## S E R V I C E N O T E

**8751A Network Analyzer**

**Modification to fix the intermittent lock up/PRESET operation**

Figure 1. A51U42 Location

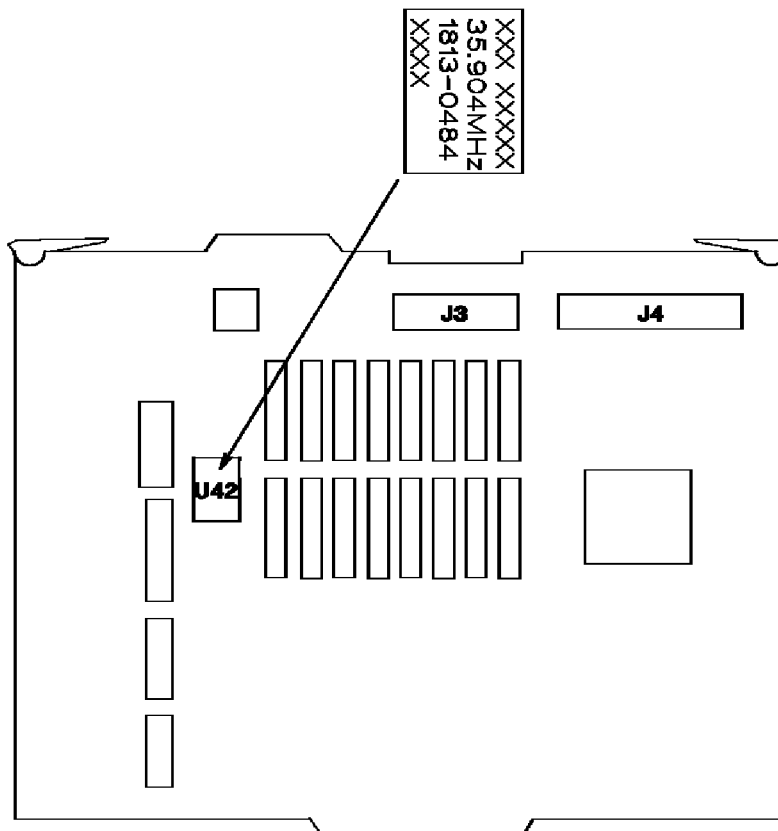
8751As may intermittently lock up, or perform unexpected PRESET operations suddenly, if a X'tal OSC (pn 1813-0484) is used at A51U42 on the 8751A A51 GSP board.

This will be caused by the A51U42 X'tal OSC which does not oscillate properly.

1. Remove the top cover from the 8751A.
2. Remove two screws restraining a plate over the A51 assembly, and remove the plate.
3. Disconnect all cables from the A51 assembly.
4. Remove A51 assembly from the 8751A.
5. Check if "1813-0484" is tagged on the A51U42 X'tal OSC component as shown in Figure 1. If it's written, replace the A51 board.

The X'tal OSC at A51U42 has been changed to an X'tal OSC (pn 1813-0865) to solve the problem. All A51 boards currently supplied for replacement has the new X'tal OSC at A51U42.

Perform the following procedure to check if the X'tal OSC (pn 1813-0484) is used at A51U41. If the X'tal OSC (pn 1813-0484) is used, replace the A51 board with new one.
